Log # TXX-93043  
 File # 10010  
 904.3  
 Ref. # 10CFR50.71(a)  
 10CFR2.790(b)

May 28, 1993

SUBJECT: COMANCHE PEAK STEAM ELECTRIC STATION (CPSES)  
 DOCKET NOS. 50-445 AND 50-446  
 RESPONSE TO REQUEST FOR ADDITIONAL INFORMATION  
 REGARDING TOPICAL REPORT RXE-90-006-P, "POWER  
 DISTRIBUTION CONTROL ANALYSIS AND OVERTEMPERATURE  
 N-16 AND OVERPOWER N-16 TRIP SETPOINT METHODOLOGY"

Figure 1: Boron Letdown Comparisons, CPSES Unit 1, Cycle 1

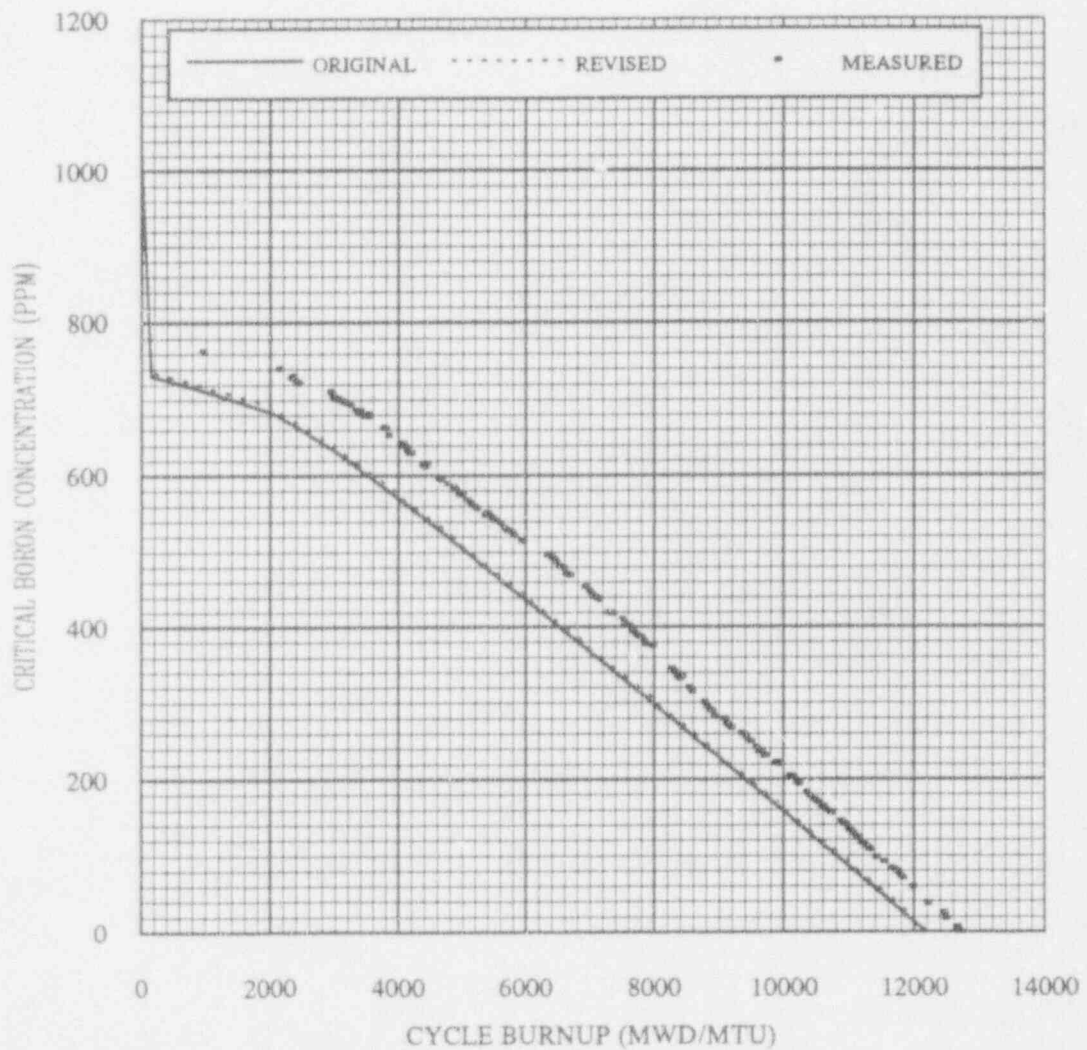
*Provide additional measured versus predicted comparisons for data measured for Comanche Peak Steam Electric Station Unit 1.*

TU Electric has investigated the differences in the predicted versus measured boron letdown comparisons, and has refined the technique for determining the appropriate fuel temperature to be used in the CASMO-3/SIMULATE-3 models for fuel types used at CPSES. The use of a refined fuel temperature remains consistent with the methods presented in approved topical report RXE-89-003-P (Ref. 3). Figures 1, 2 and 3 display the effects of the refined fuel temperature on the boron letdown and provide comparisons with measurement. Differences between TU Electric and fuel vendor boron letdown predictions for Cycle 3 are about 20 ppm at beginning of cycle. There are essentially no differences from mid-cycle on.
